ADDENDUM NO. 05

Murrieta Mesa High School New Classroom Building – DSA 04-118451 MURRIETA VALLEY UNIFIED SCHOOL DISTRICT

Project No - 02132020
DSA No. - 04-118451

5 CROSS SECTION @ STAIR SOFFIT SUPPORT
A3.1 1 1/2" = 1'-0"

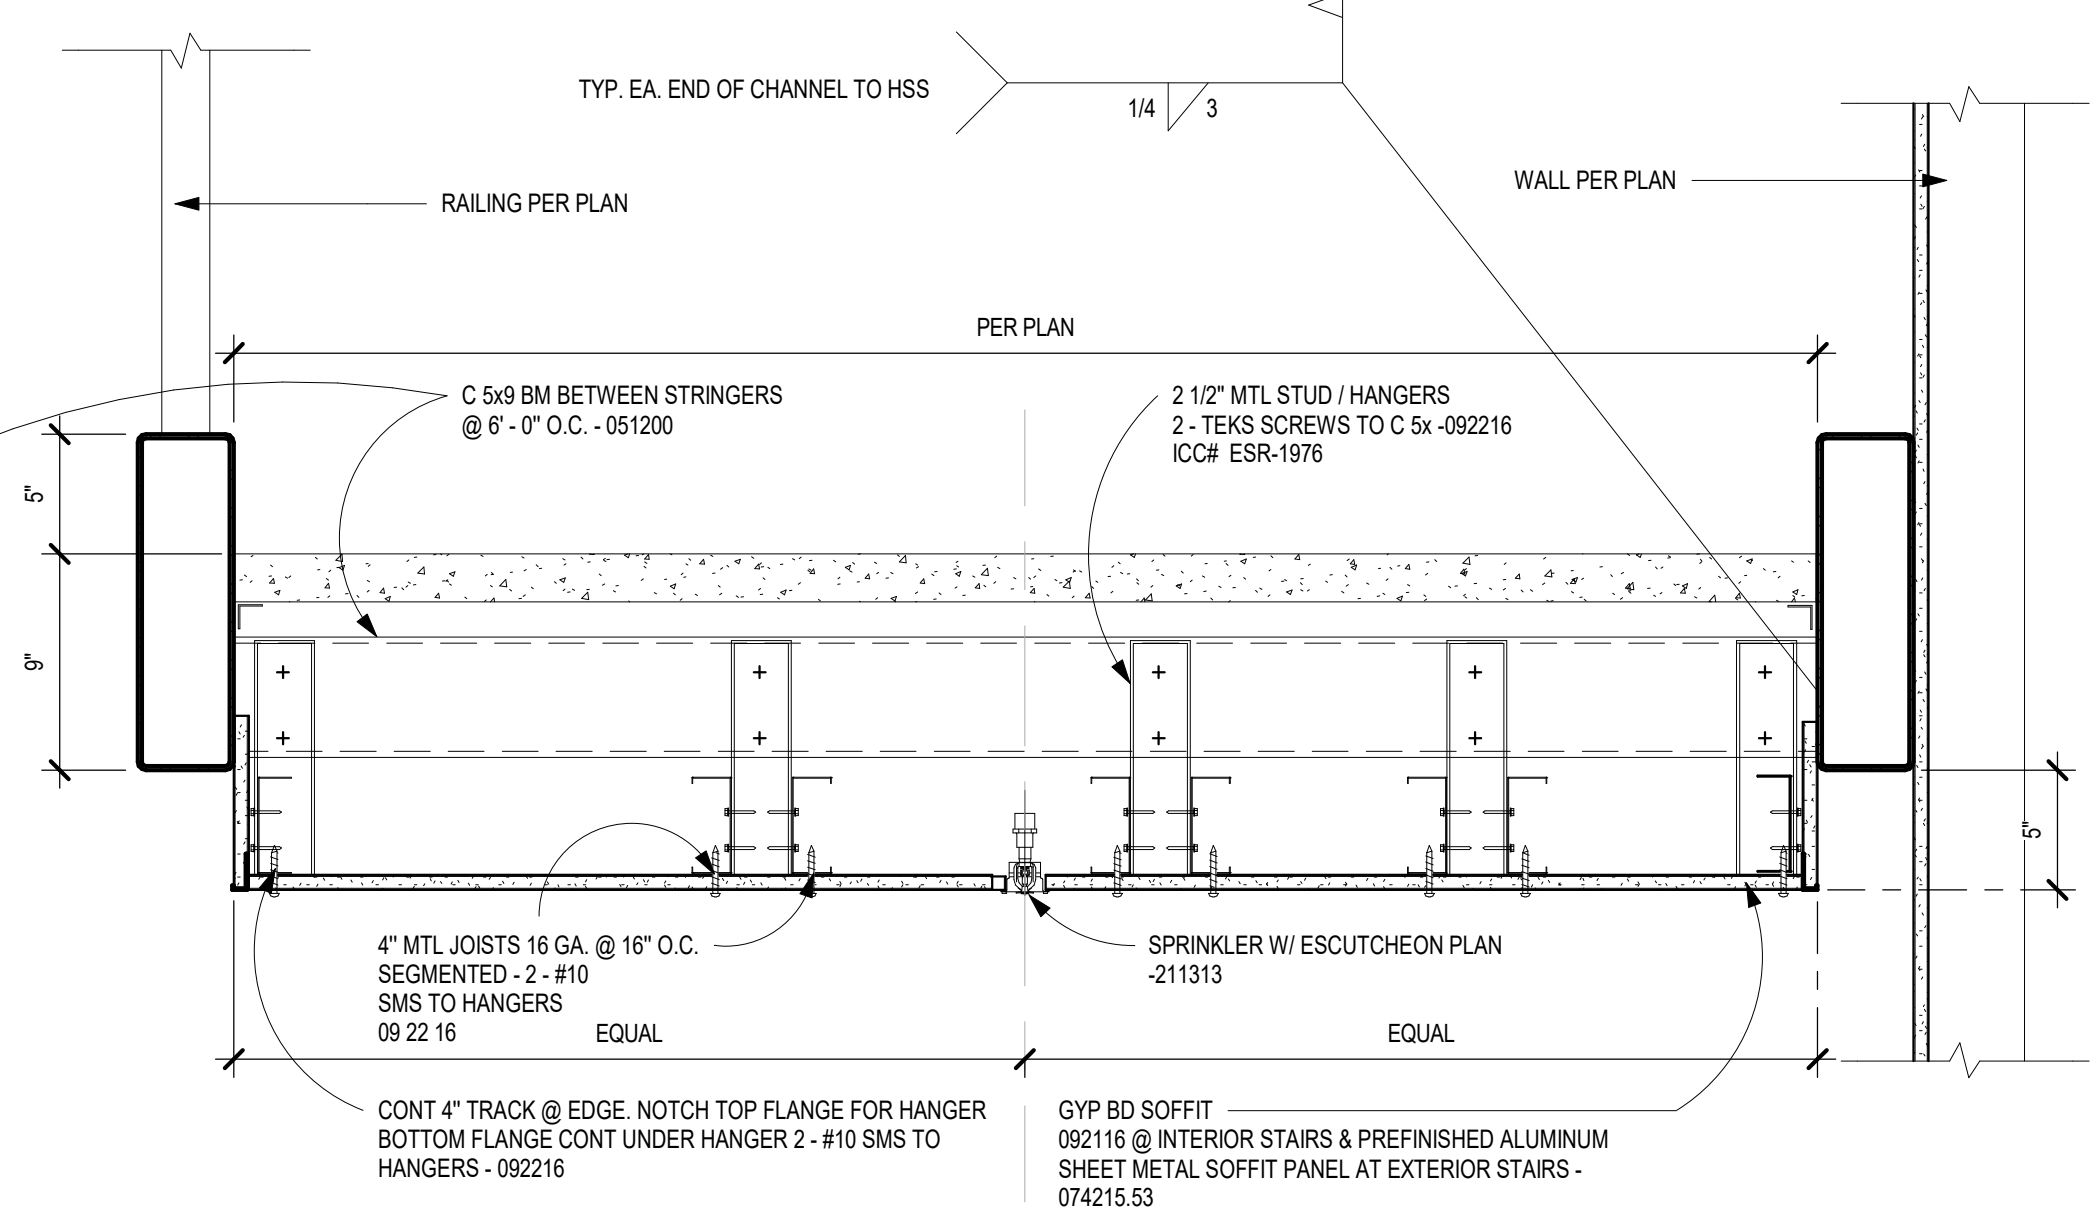
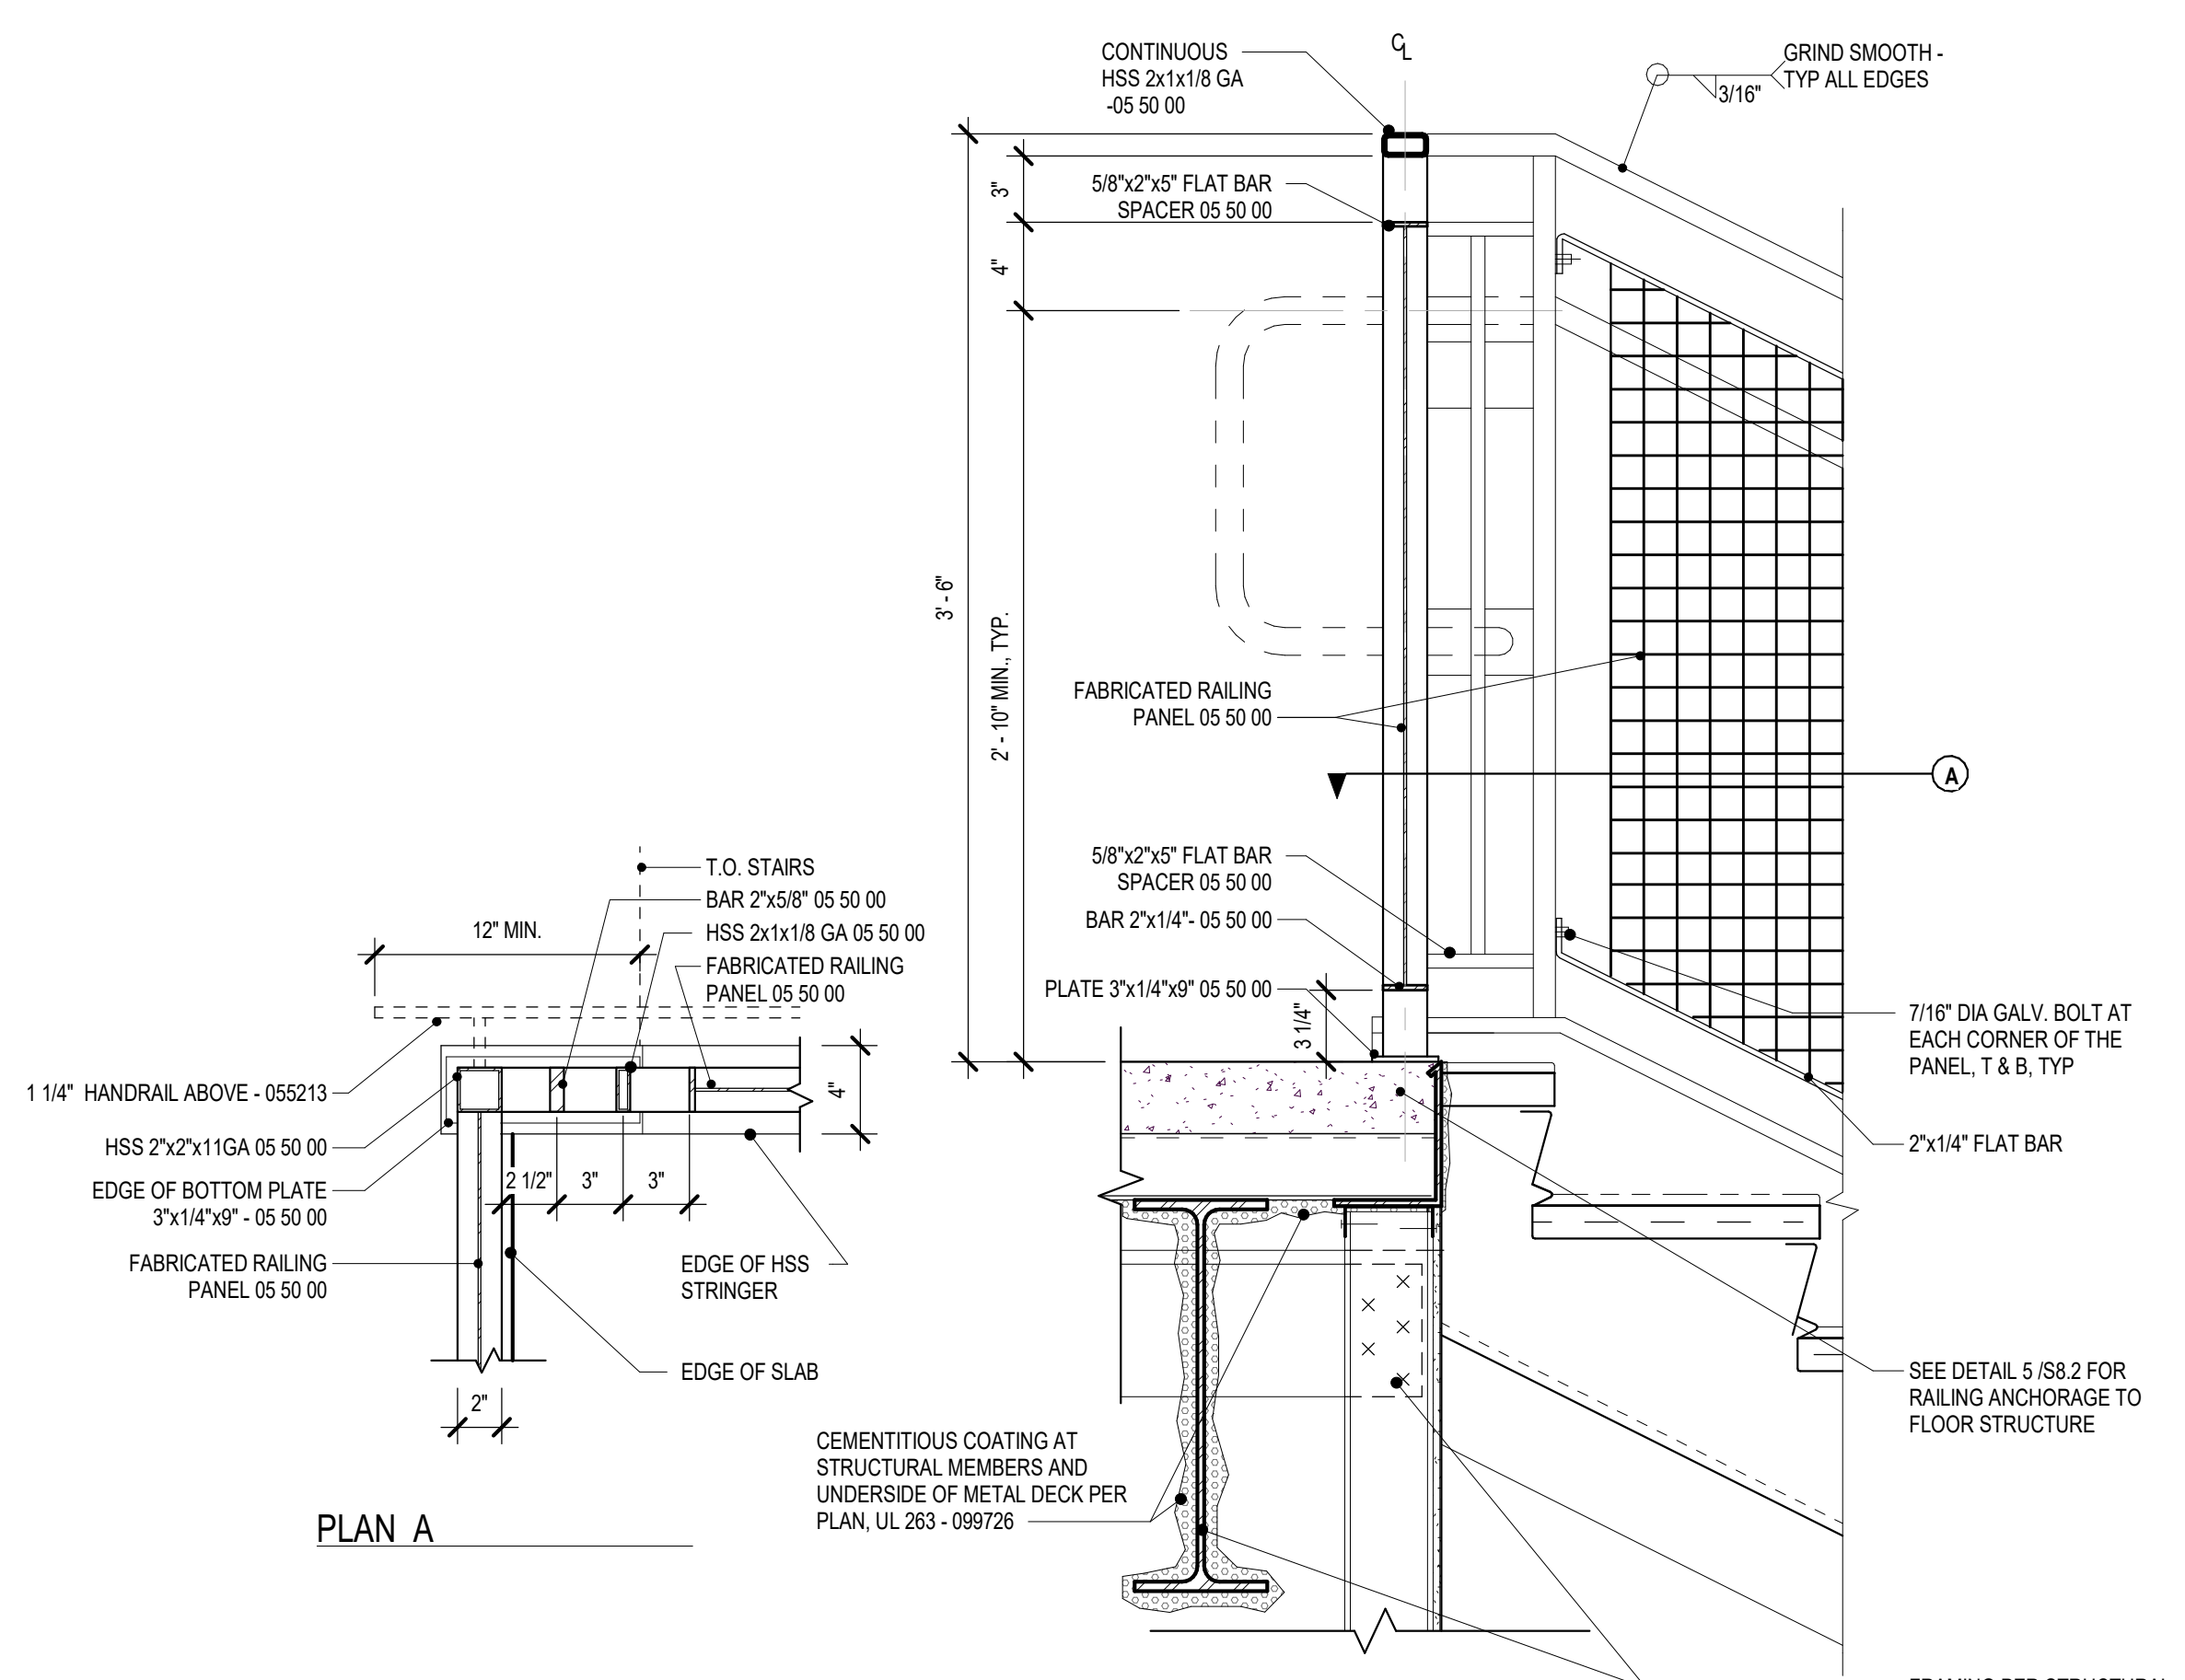
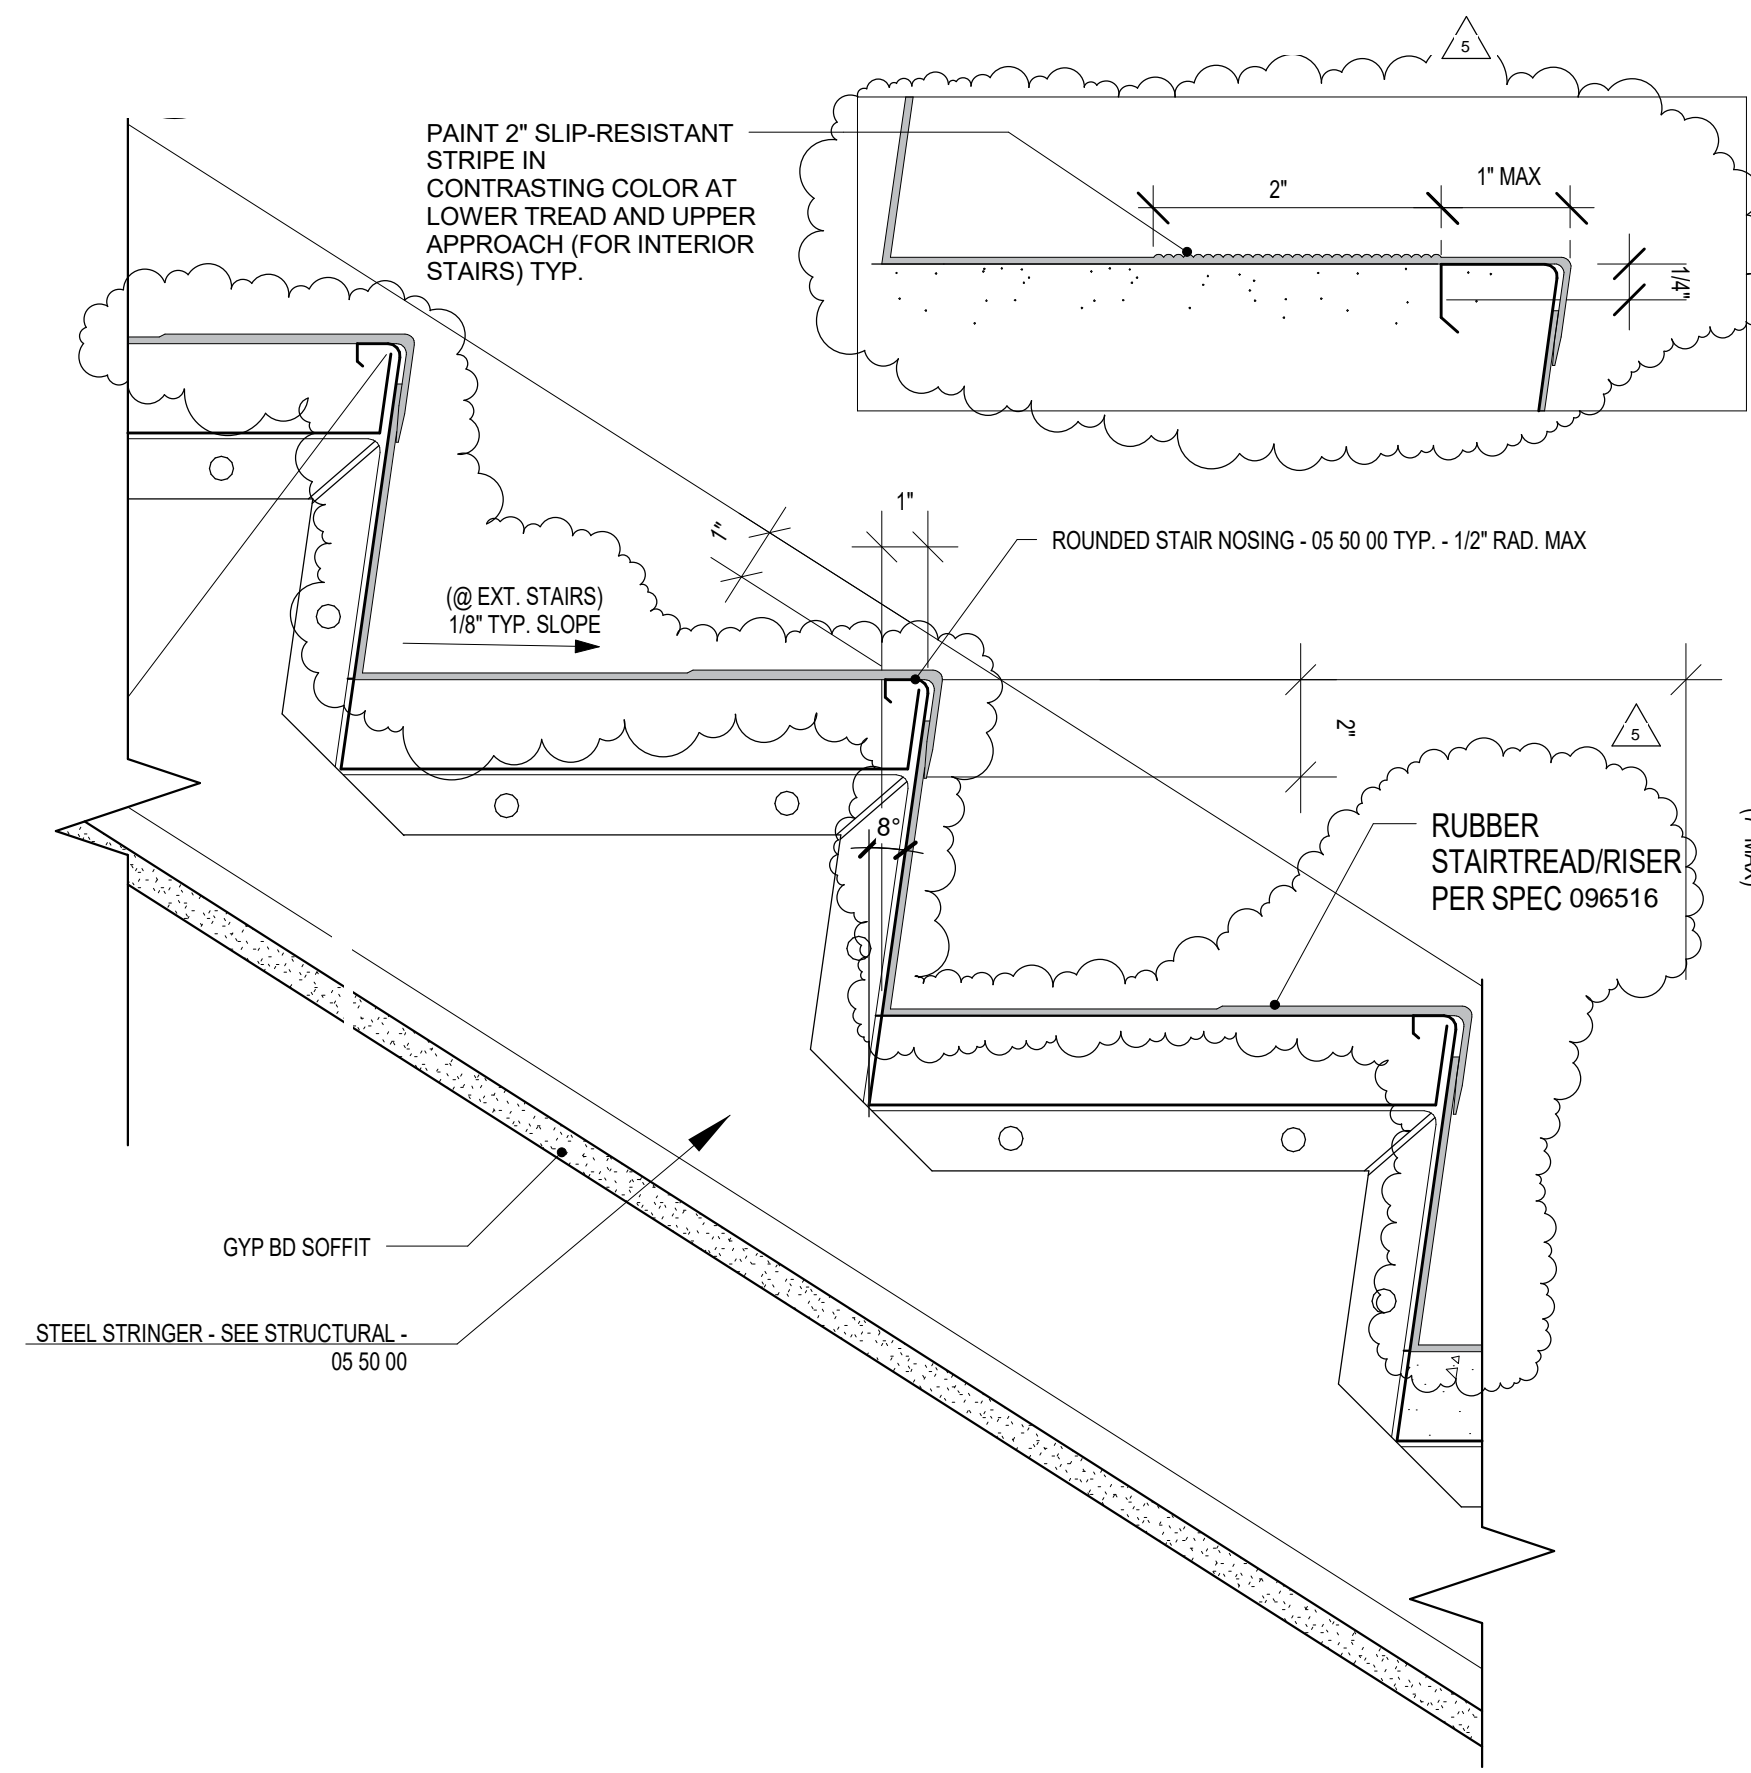
b. SHEET NO. A9.17 / DETAIL 6

Revise currently issued drawing per AD5-A15.

DRAWING
S0.3
AD5-S01

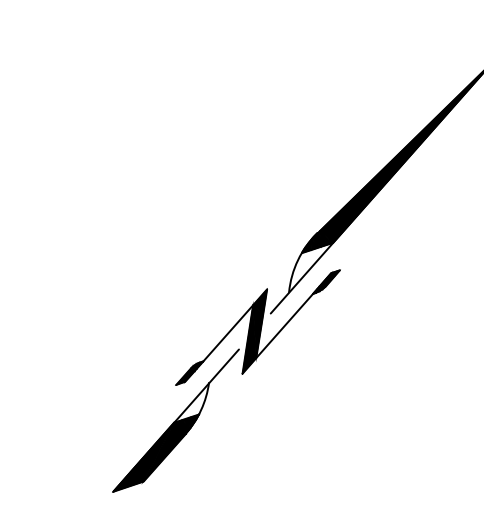
- a. **SHEET NO. S0.3**
Bid Package No. 01, Bid Package No. 13, Bid Package No. 14 –
Revise currently issued drawing per AD5-S01.

Drawing Sheet C-4.1 reflects a new 18" Reinforced Concrete Pipe (RCP) Storm Drain Line to be installed. This line if installed would be directly below the "Site Electrical Duct Bank of Conduit" and water lines. These electrical conduit duct bank and water lines would not be able to be safely supported. See attached photos reflecting the site utility markings, and also reference the attached Sketch SK-001 S.D.-RCP. We proposed to utilize the existing 18" RCP storm drain lines to the existing storm drain system. Please review and advise.

The existing storm drain line is to be utilized rather than demolishing and relocating it.
3-sack slurry to be provided under footing along south side of the building to drop the zone of influence away from the existing storm drain. See Addendum 5 with updates on sheets C2.1, C3.1, C4.1, and S0.3.
